Access Compliance Report

Public Rights-of-Way

(Curb Ramps)

Intersection ID: 4194	Main Street: COLVARD_PARK_WY	Cross Street: MALLARD_CREEK_RD	Location: SW
ADA ID: C2682E93A98A	Ramp Type: Perp	Initial Pass/Fail: Fail	Overall Compliance: No
Severity Score: 22.5			
Codes/Mitigation Info/Possible Solution		Field Measurements/Component Compliance

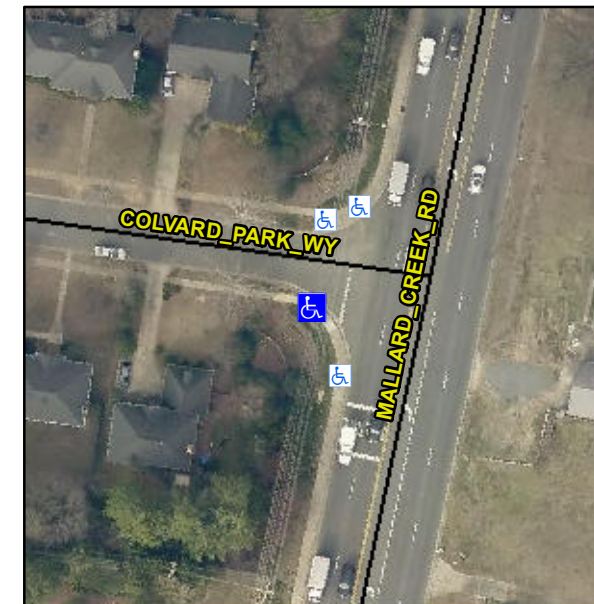
R304.5.1, R304.2.2, R304.5.3

Compliance	Description	Data	Compliance	Description	Data
N/A	Ramp Length (in)	59.0	No	Ramp Slope (%)	11.2
No	Ramp Width (in)	40.0	No	Ramp XSlope (%)	3.3
N/A	Flare Type LT	N/A	N/A	Flare Type RT	N/A
N/A	Flare Slope LT (%)	N/A	N/A	Flare Slope RT (%)	N/A
N/A	Flare Traversable LT?	N/A	N/A	Flare Traversable RT?	N/A
N/A	Landing Length (in)	N/A	N/A	DWS Provided?	N/A
N/A	Landing Width (in)	N/A	N/A	DWS Contrast?	N/A
N/A	Landing Slope (%)	N/A	N/A	DWS Length (in)	N/A
N/A	Landing X Slope (%)	N/A	N/A	DWS Full Width?	N/A
N/A	Landing Curb? (Y/N)	N/A	N/A	DWS Offset (in)	N/A
N/A	Shared Landing?	N/A			
N/A	Gutter Ponding?	N/A	N/A	Gutter Slope (%)	N/A
N/A	Gutter Lip Ht (in)	N/A	N/A	Gutter X Slope (%)	N/A
N/A	Painted X Walk1?	No	N/A	Painted X Walk2?	N/A
	X Walk 1 Direction	To N		X Walk 2 Direction	N/A
N/A	X Walk 1 Width (in)	N/A	N/A	X Walk 2 Width (in)	N/A
	X Walk 1 Slope (%)	0.5		X Walk 2 Slope (%)	N/A
	X Walk 1 X Slope (%)	2.4		X Walk 2 X Slope (%)	N/A

Remove & Replace Entire Ramp.
